ADDENDUM NO. 1 TO PROJECT NO. 47261

CONSTRUCTION WORK PROVIDE MASONRY REPAIRS, FAÇADE, BUILDING 40 CREEDMOOR PSYCHIATRIC CENTER 80-45 WINCHESTER BOULEVARD QUEENS VILLAGE, NY

January 9, 2026

REGISTRATION EXPIRES:
02/28/2026

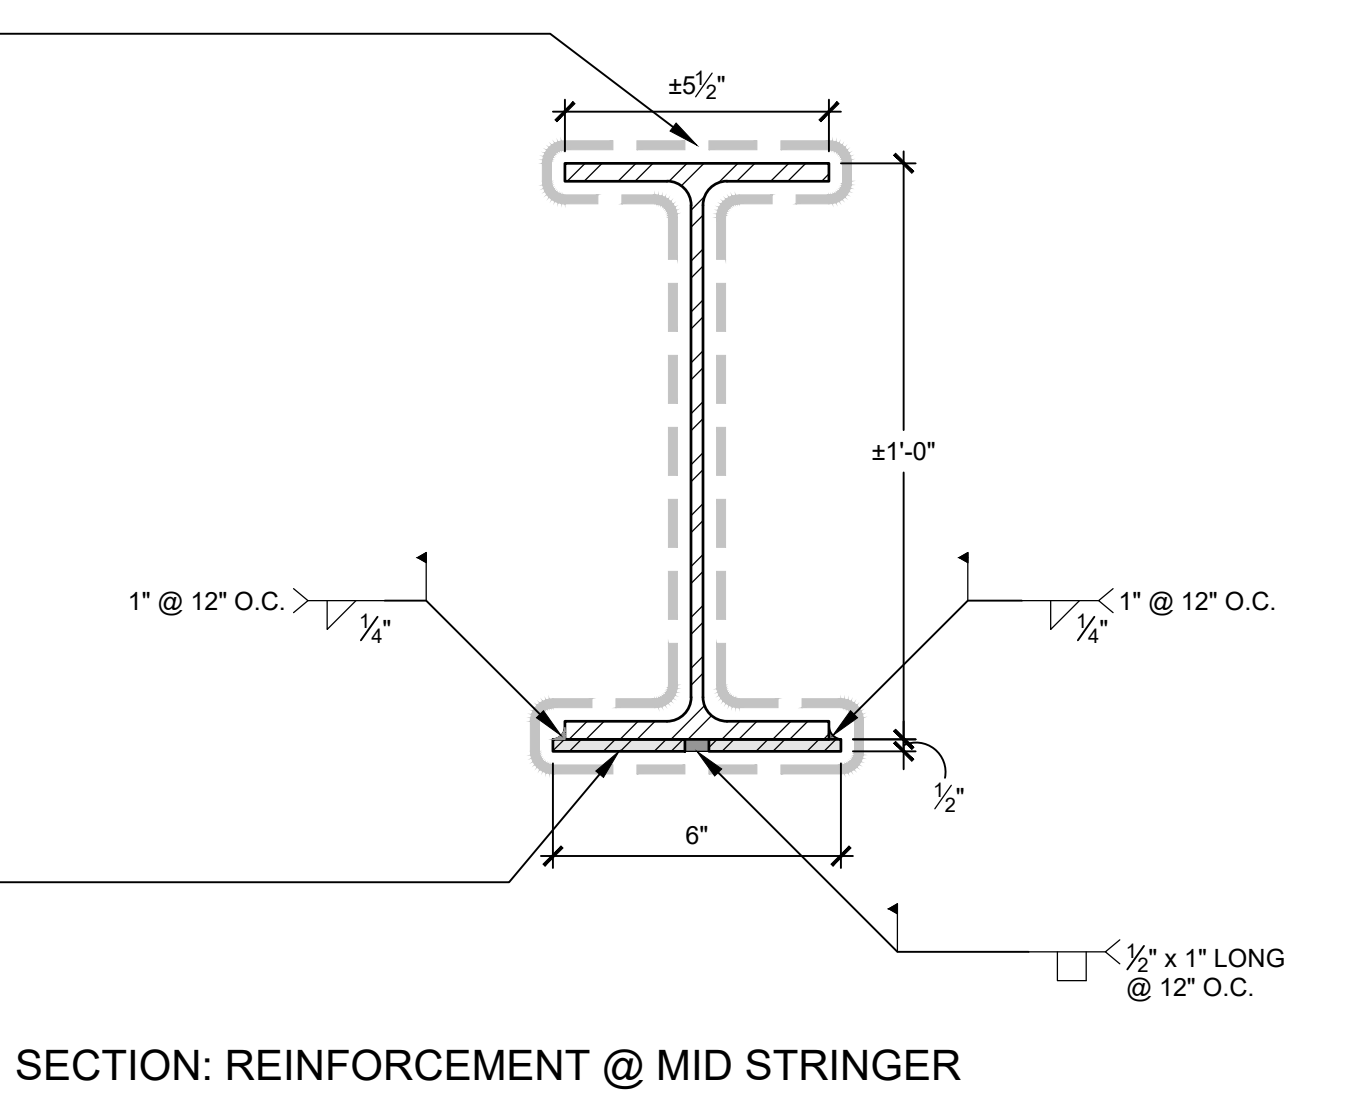
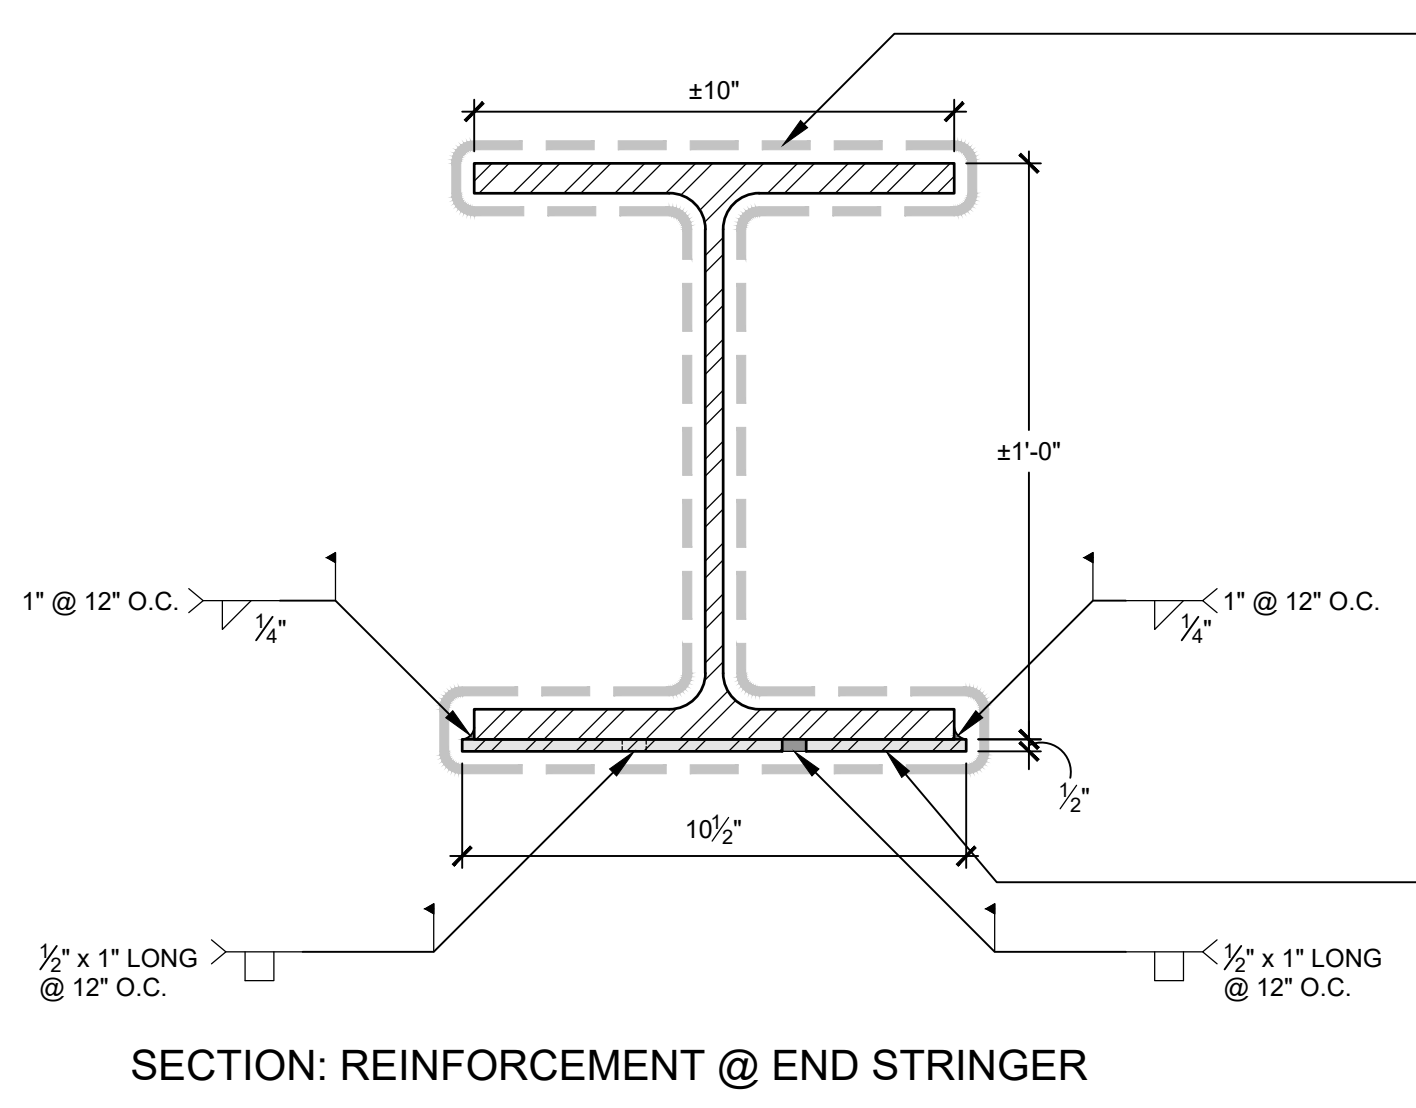
8. Drawing No. A-546
 - a. Included note of location of traffic coating application.
9. Drawing No. A-568
 - a. Included note of location of traffic coating application.
10. Drawing No. A-574
 - a. Included note of location of traffic coating application.
11. Drawing No. A-585
 - a. Included note of location of traffic coating application.
12. Drawing No. A-588
 - a. Included note of location of traffic coating application.
13. Drawing No. A-590
 - a. Included note of location of traffic coating application.
14. Drawing No. A-592
 - a. Included note of location of traffic coating application.

CLEAN AND PREPARE TOPSIDE SURFACE OF CONCRETE STAIRS AND LANDING AND APPLY TRAFFIC COATING PER MANUFACTURER'S INSTRUCTIONS, TYP.
